98-8, *Publication Date: APRIL 27, 1998*

<b>Fluid - Transmission Fluid Usage Charts</b>	<b>Article No. 98-8-8</b>
--	-------------------------------

This TSB article is being republished in its entirety to update the Application Chart.

Figure 1 - Article 98-8-8

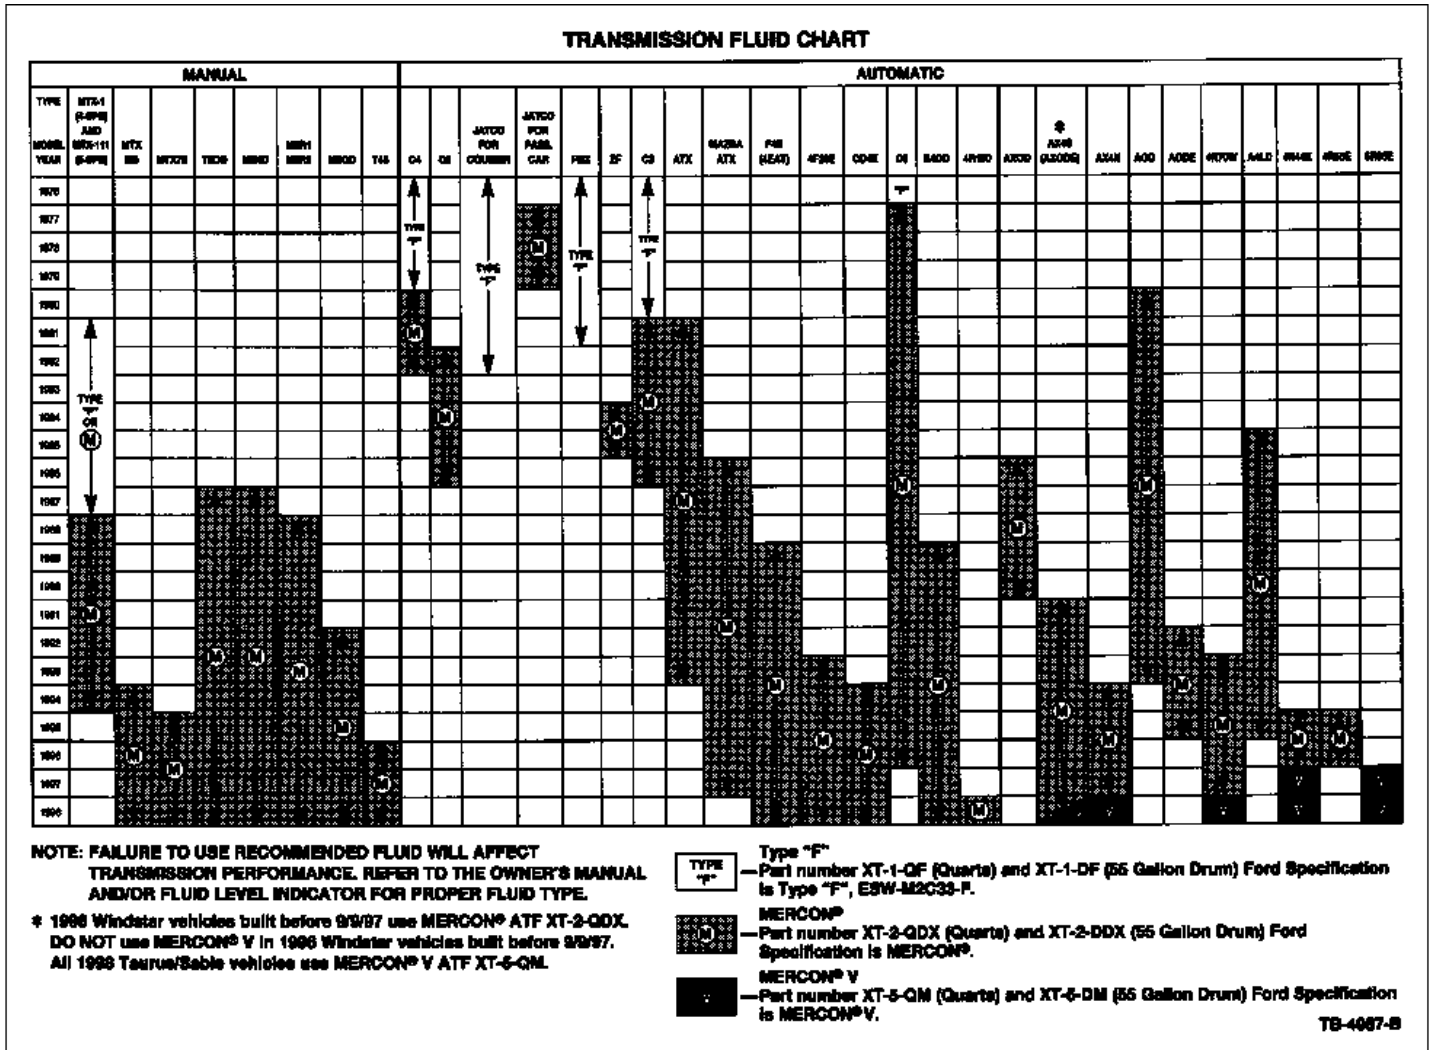
A new automatic transmission fluid (MERCON® V) was introduced in 1997 for use in vehicles equipped with a 4R44E or 5R55E transmission. In the 1998 model year, MERCON® V fluid is now used in the 4R70W transmission and AX4S and AX4N transaxles. MERCON® V **is not interchangeable** at this time with the

current MERCON® service fluids.

Using the incorrect fluid may cause transmission or transaxle concerns. Refer to Figure 1 for proper fluid applications on current and past model vehicles equipped with a manual or automatic transmission or transaxle.
